National Dioxin Study Tier 4 - Combustion Sources: Quality Assurance Evaluation

Quality Assurance Evaluation

Quality Assurance Evaluation

Figure 1. Configuration of primary and back-up sorbent modules in Modified Method 5 sampling train.

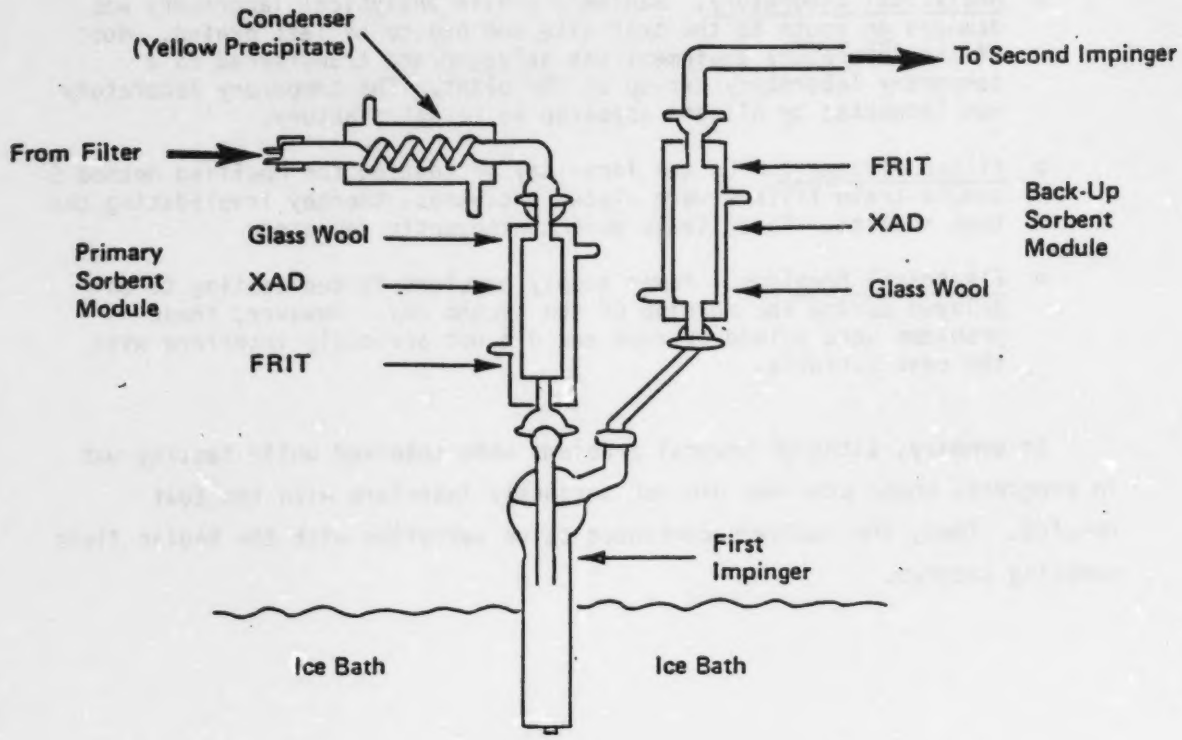
The Modified Method 5 sampling train in use at the Site MET-A tests was unique in that a second XAD resin cartridge was added to the system just after the first impinger, as illustrated in Figure 1. This configuration, which was requested by EPA, was designed to mitigate concerns regarding the horizontal position of the XAD condenser. (Although the horizontal mounting of the condenser had been approved by EPA during previous Tier 4 tests, officials from a State Agency remained concerned about an increased potential for organic compounds breaking through the resin.) The set-up and operation of the second XAD resin cartridge appeared to be acceptable. Furthermore, with one exception, operation of the entire train appeared normal. The one exception involved the formation of a yellow precipitate in

the condenser, between the filter and the first XAD resin cartridge. The nature of this precipitate is unknown, although its color suggests it may be chloride. Radian reported that the precipitate was easily removed with acetone.
